Re: Hudson Valley Shakespeare Festival
Amendment to Proposed Plan and Evaluation of Reduced Impacts

Subject: Hudson Valley Shakespeare Festival
Traffic Analysis for Modified HVSF Development Program

Reduced Site Plan - Indoor Theater and Inn Removed

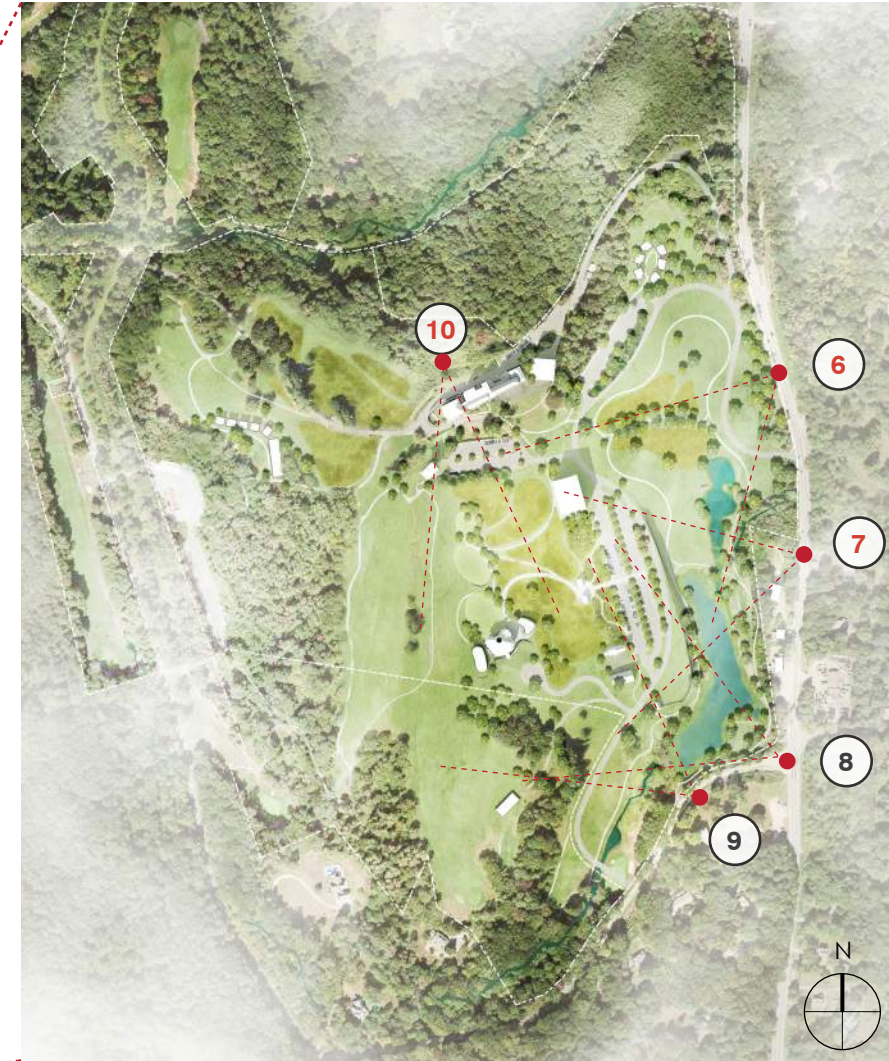
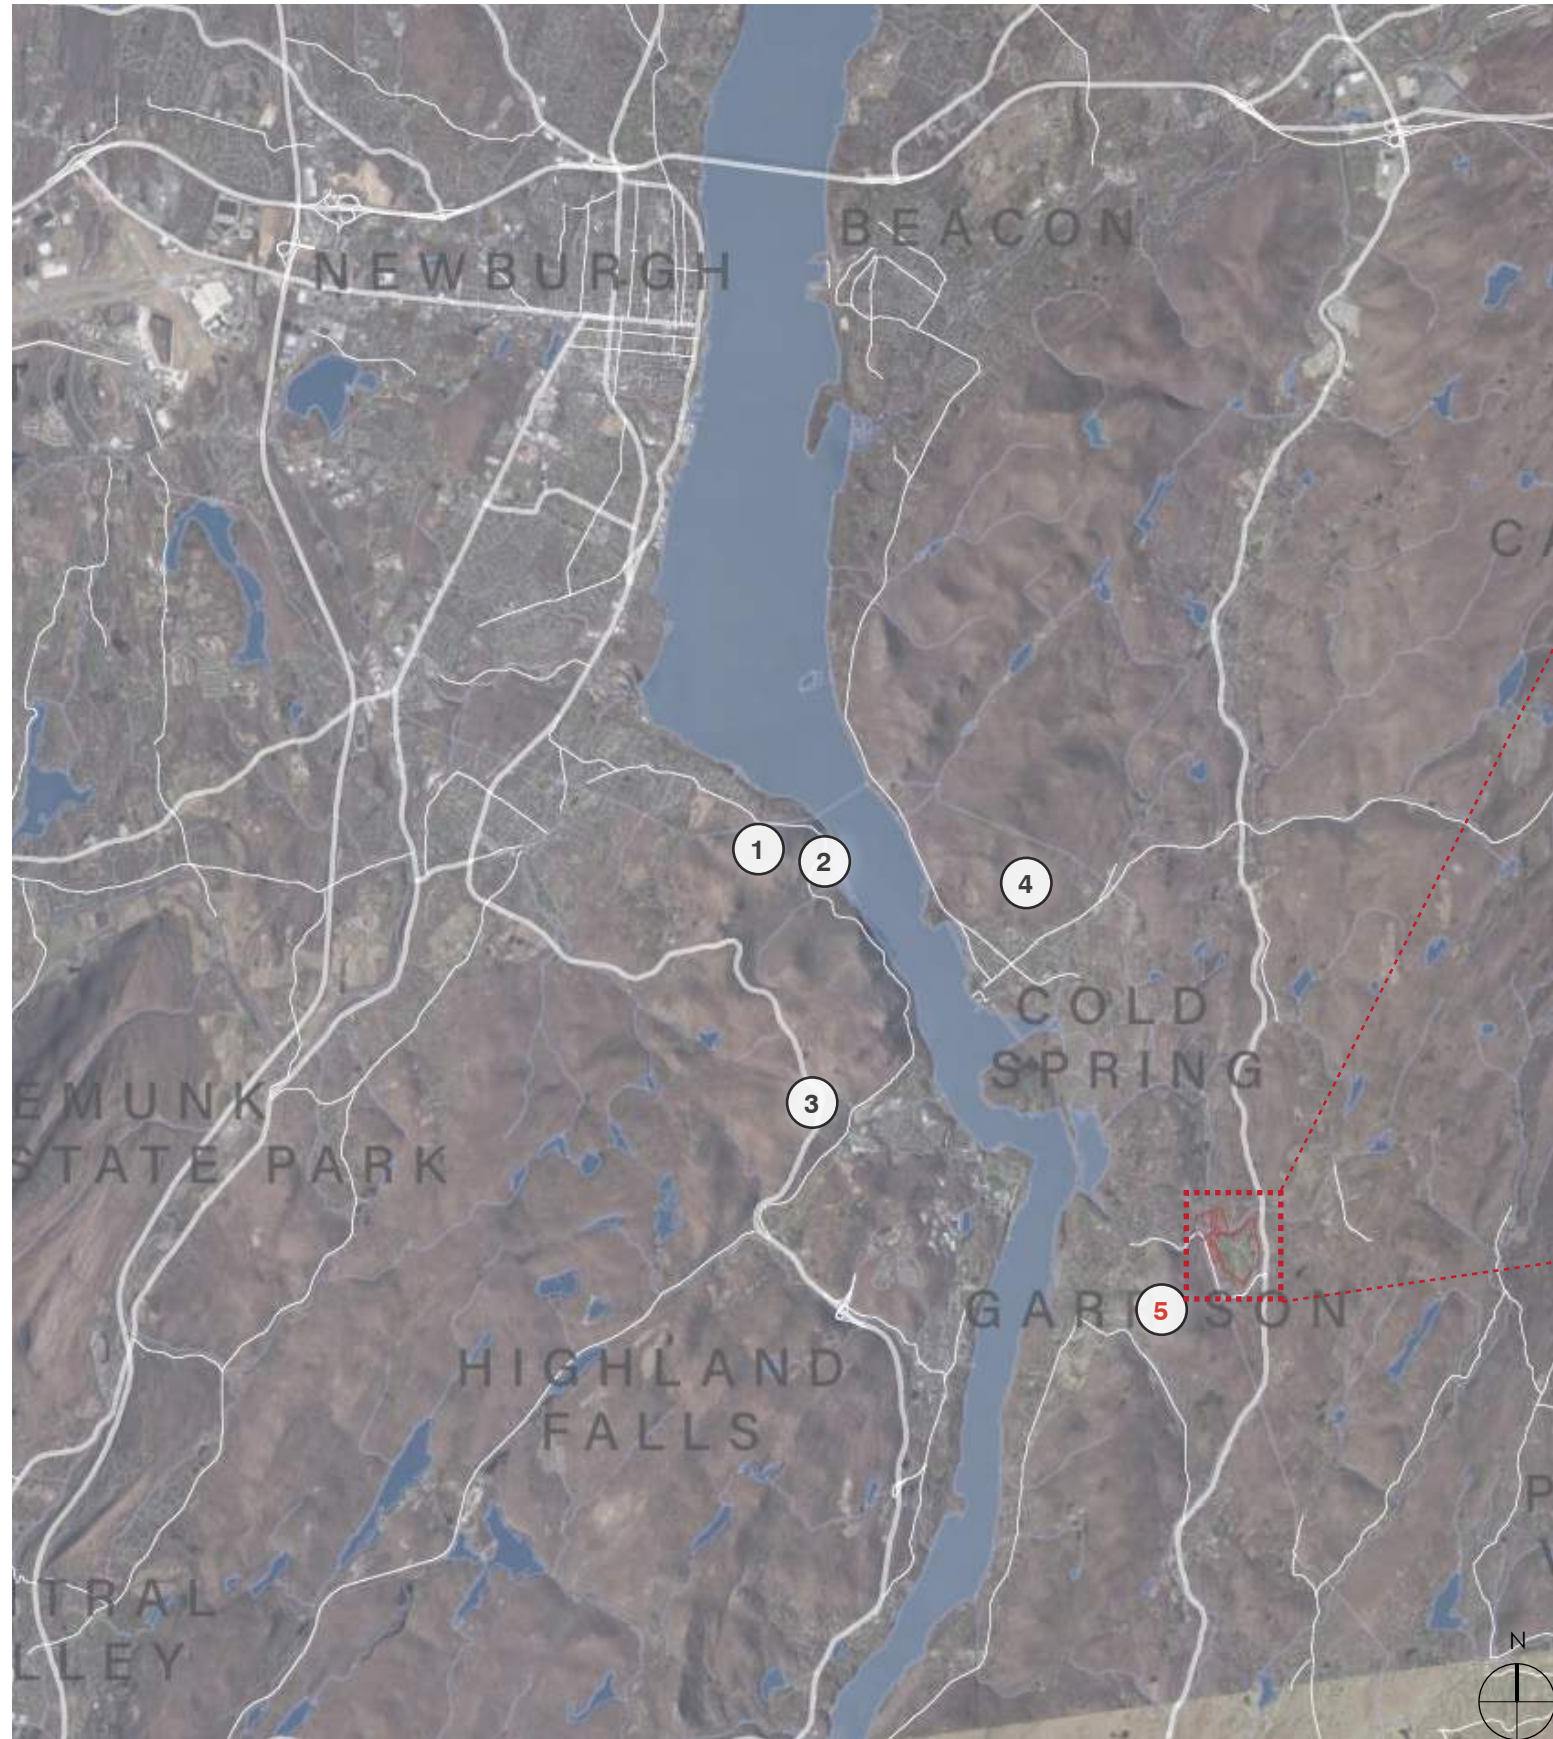
| ① Theater Tent | ⑥ Pervious Parking Lot (236 Spaces) - ADJUSTED TO AVOID WETLAND BUFFER | ⑪ 6 Artists and Guest Lodging Buildings | ⑬ 5 Artist and Guest Lodging Buildings + 1 Amenity Building | ⑰ Wedding Venue | ⑳ Existing Parking Lot | ㉒ Pervious Parking - Staff and Event Overflow (130 Spaces) | ㉔ Meadow Plantings |
| ③ Concessions and Restrooms | ⑧ Welcome Garden | ⑬ 5 Artist and Guest Lodging Buildings + 1 Amenity Building | ⑮ 20-Room Hotel - REMOVED | ㉒ Pervious Parking Lot (6 Spaces) - REDUCED | ㉓ New Snake Hill Road Entrance | | |
| ④ Picnic Lawns | ⑨ Rehearsal and Administration | ⑯ Year-Round Theater - REMOVED | | | | | |

~1400' **6** NEW Winter View from Route 9 looking south -- THEATER REMOVED
Designated NYS Scenic Road

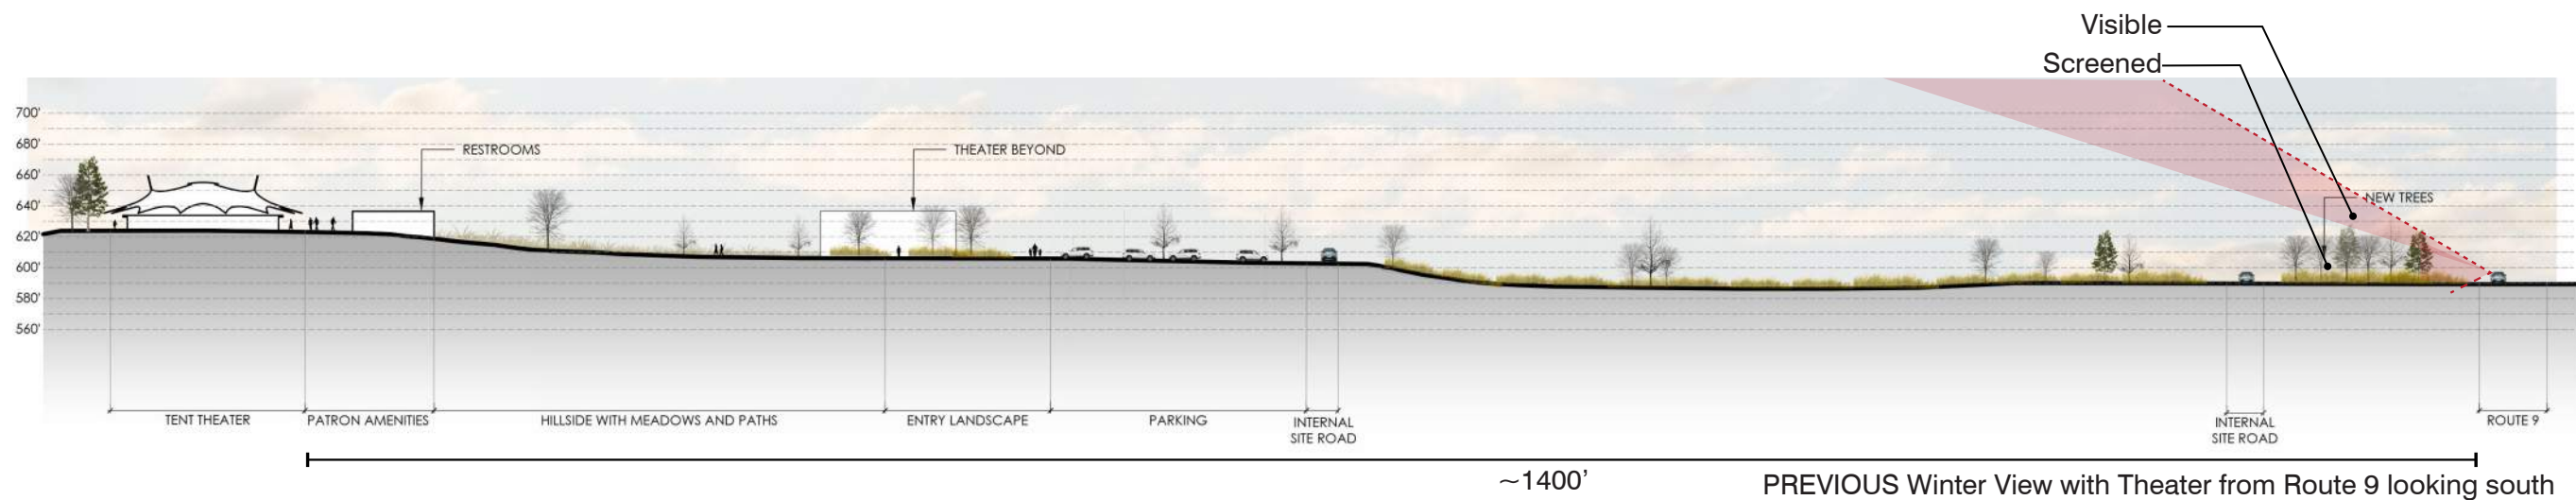
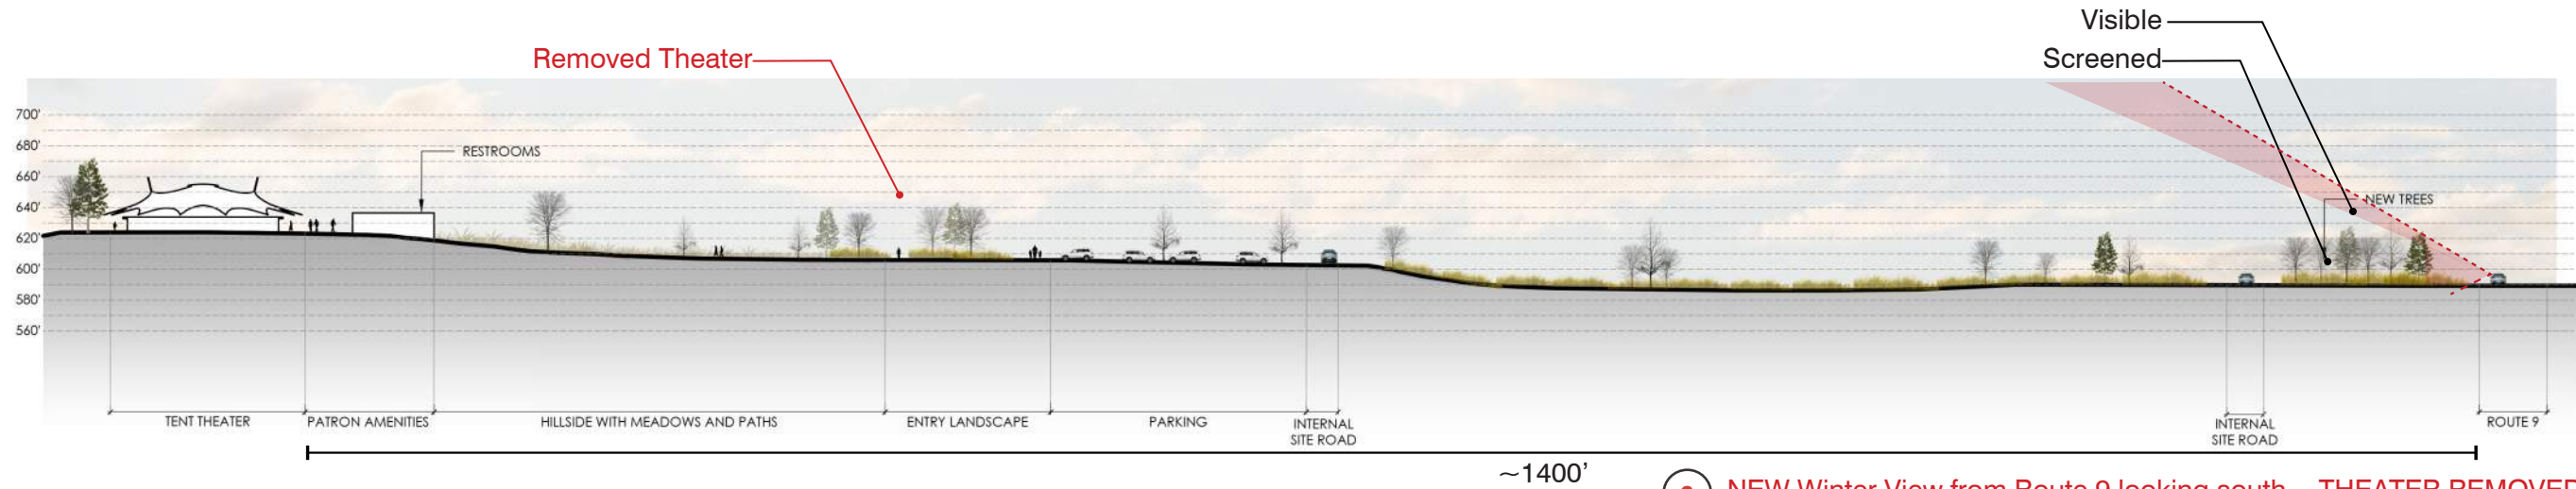
~1400' PREVIOUS Winter View with Theater from Route 9 looking south
Designated NYS Scenic Road
